SCHEME - FOUR
WITH SHORTER BUILDING
AND REVISED PARKING

LAQUINTA INN & SUITES

HATTIESBURG, MISSISSIPPI

SITE PLAN
SCHEME-4

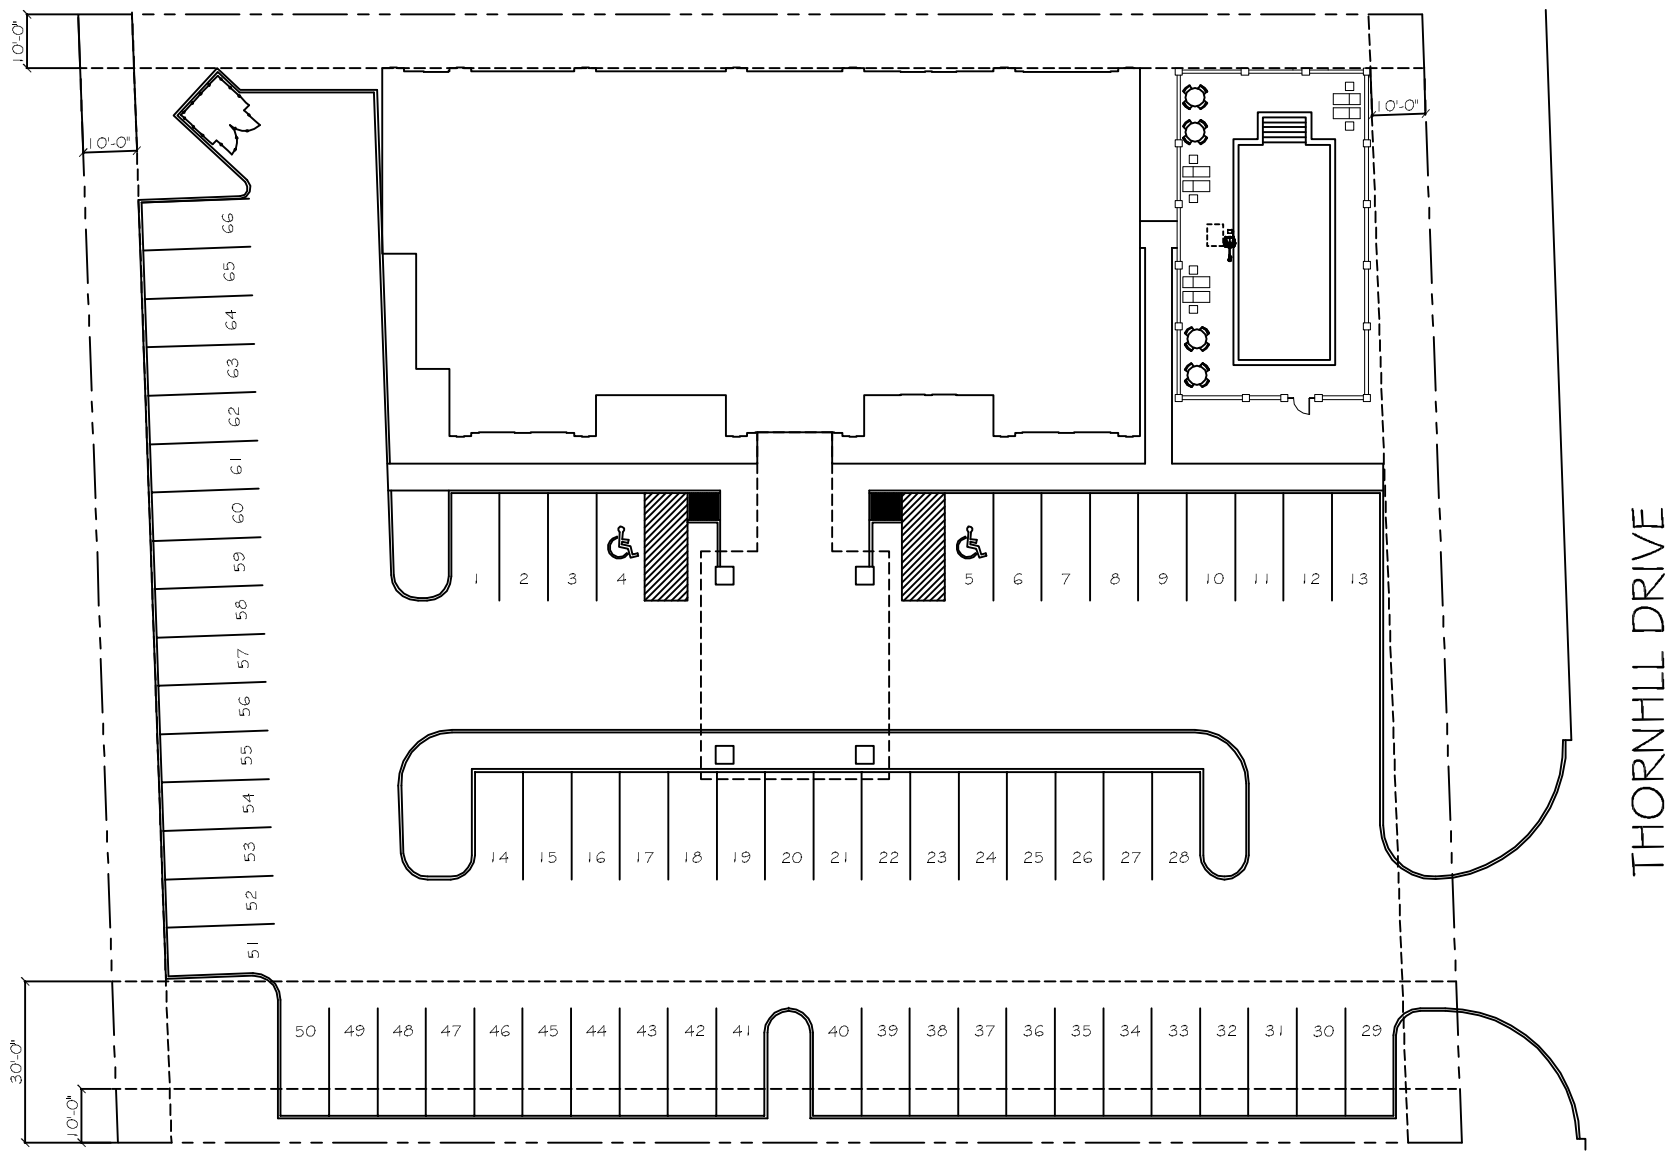
WROND SETBACK AT ROAD
SHOULD BE 30 FT. (NOT 10')
